UNITED STATES PATENT AND TRADEMARK OFFICE

APPLICATION NO.	FILING DATE	FIRST NAMED INVENTOR	ATTORNEY DOCKET NO.	CONFIRMATION NO.
10/509,900	08/17/2005	Manfred Malle	Vinazzar 2	2982

Office Action Summary

ATTACHMENT

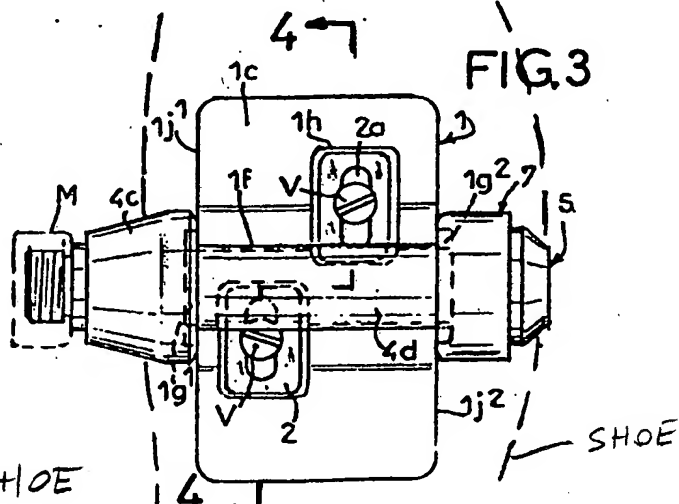
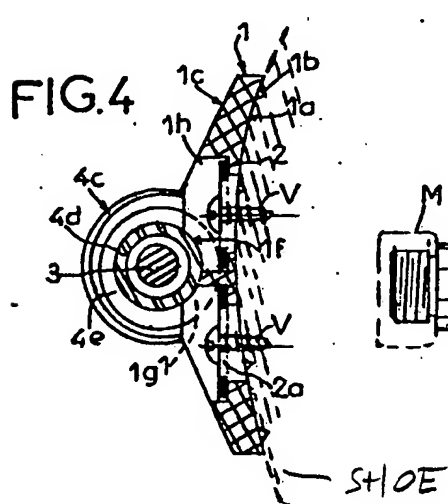
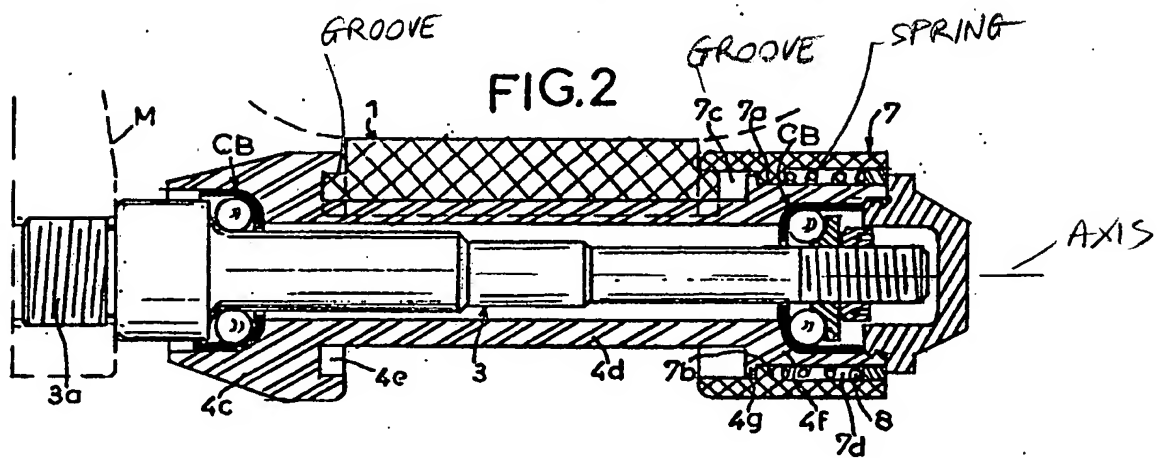
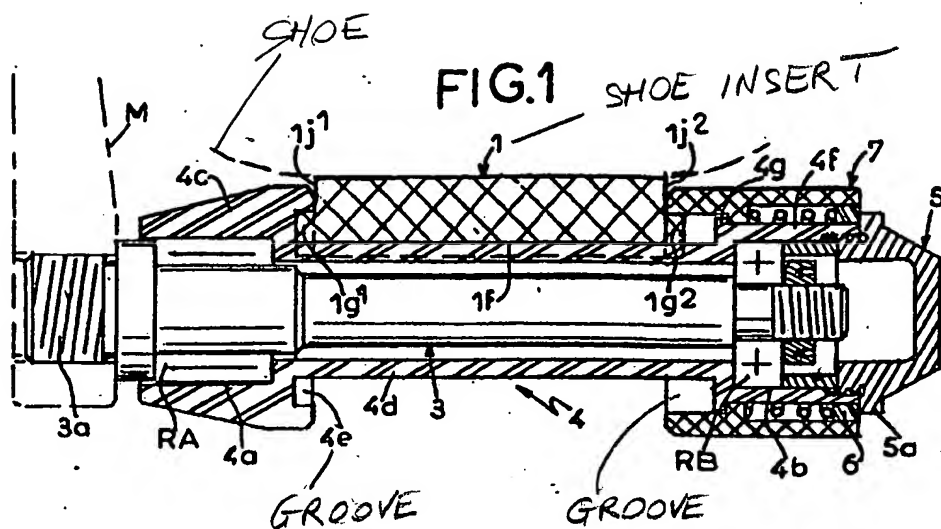
Regarding claim 1, Lyotard teaches a pedal system for bicycles comprising a shoe insert 1, which can be fastened on a shoe (shown by dashed lines, see Attachment hereinafter “Att.”)

and has a detent element $1g^1$, $1g^2$ (FIG. 1) and a pedal 4, which can be fastened on the bicycle and can be rotated about an axis (Att.), and which pedal 4 has a seat 4c, 7 for the detent element $1g^1$, $1g^2$, in which seat said detent element $1g^1$, $1g^2$ can be locked against elastic force, and from which seat 4c, 7 same can be released by carrying out a rotating movement, wherein the seat 4c, 7 is formed between two seat parts 4c and 7, which are designed rotationally symmetrically with respect to the pedal axis (Att.), and which can be moved away from one another against elastic force in direction of the pedal axis (Att.).

Regarding claim 2, the seat parts 4c and 7 form or have receiving grooves 4e and 7c (Att.) facing one another.

Regarding claim 3, one (7) of the two seat parts 4c and 7 can be moved against the force of at least one spring (Att.).

Regarding claim 6, at least one pressure spring (FIGS. 1 and 2, see Att.) is provided as the spring, which pressure spring is supported with its one end on an abutment connected to the sleeve 4c, 4d and with its second end on the second sleeve 7.

Regarding claim 11, the control element 1a has supporting wings (Att.) extending laterally of the detent element $1g^1$, $1g^2$, the insides of which supporting wings 1a (Att.) come into contact or are in contact with outer surface areas of the sleeves 4c, 4d and 7, which outer surface areas extend cylindrically and rotationally symmetrically with respect to the pedal axis (Att.), and are curved with a radius (at 1f in FIG. 4), which is smaller than the radius of the outer surfaces of the sleeves 4c and 7 as seen in FIG. 4.

Regarding claim 12, the control element 1 (Att.) can be connected to the shoe (Att.).

FIG.5

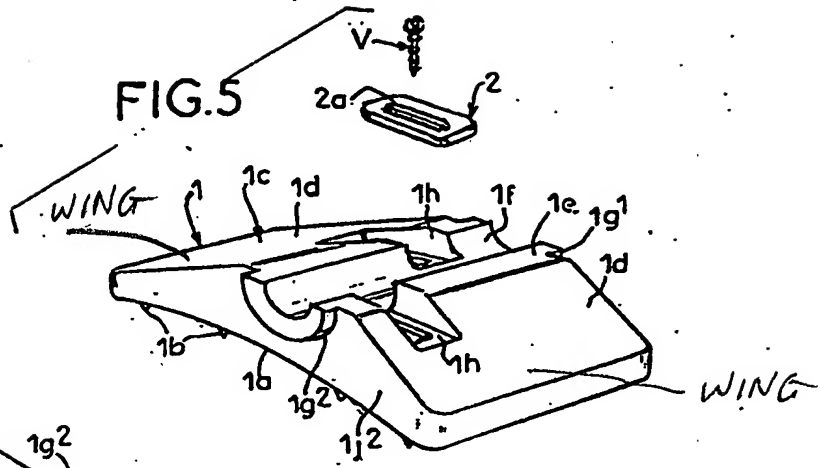
Regarding claim 9, the detent element $1g^1$, $1g^2$ has side surfaces, which have in particular centrally each one cam 1f (FIGS. 5 and 6).
